2022/0508/P - The Side House, 18 Parkhill Road

Delegated Report (Members Briefing)		Analysis sheet		Expiry Date:	06/04/2022
		N/A		Consultation Expiry Date:	01/05/2022
Officer			Application Number(s)		
Obote Hope			2022/0508/P		
Application Address			Drawing Numbers		
18 Parkhill Road London NW3 7DH			Please refer to draft decision notice		
PO 3/4	Area Team Signature	C&UD	Authorised Officer Signature		
Proposal(s)					
Erection of single storey extensions to the front and rear elevations at lower-ground floor level and alterations to fenestration to the front and rear elevations.					
Recommendation(s):		Grant conditional planning permission			
Application Type:		Householder planning application

Erection of a single storey extensions to the front and rear elevation at lower-ground floor level and alteration to the fenestration treatment.

Image 5. Proposed front elevation.

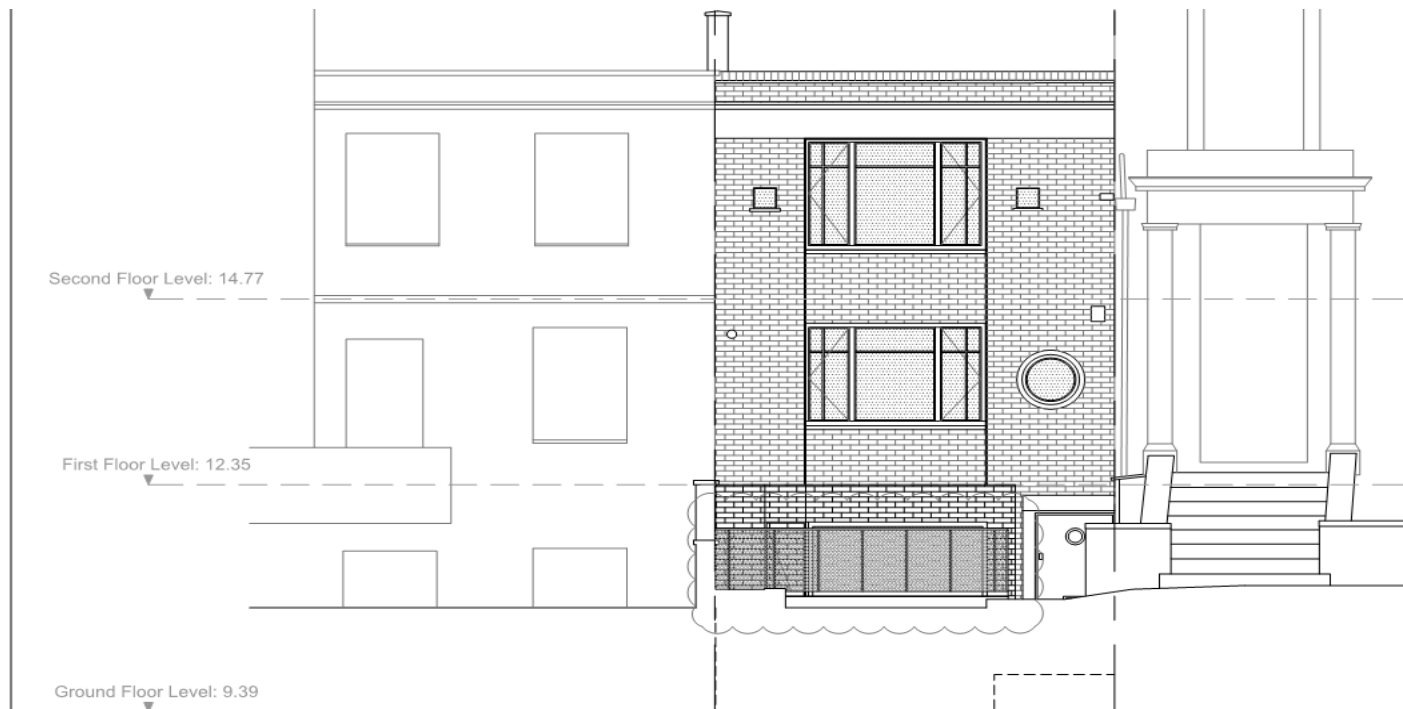
- 1.5 Changes have been made to the fenestration. A glazed balustrade has been removed to the front and the size of windows has been reduced.

3.7 The proposed fenestration treatment to the front elevation has been revised. Originally, the proposed works would involve changing all of the existing windows/door to the front and rear elevations. The host building is of limited merit and does not contribute positively to the character and appearance of the conservation area, as revised the proposed timber framed windows and the introduction of glazing bars these are welcomed addition to the original design of the host building. Thus, the proposed windows would enhance the character and appearance of the area. A condition is attached to ensure all new windows would be timber framed with glazing bars.

- 5 The proposed windows to the front elevation at ground and first floor levels shall be timber framed and fitted with glazing bars as shown on the approved plans/elevation drawing.
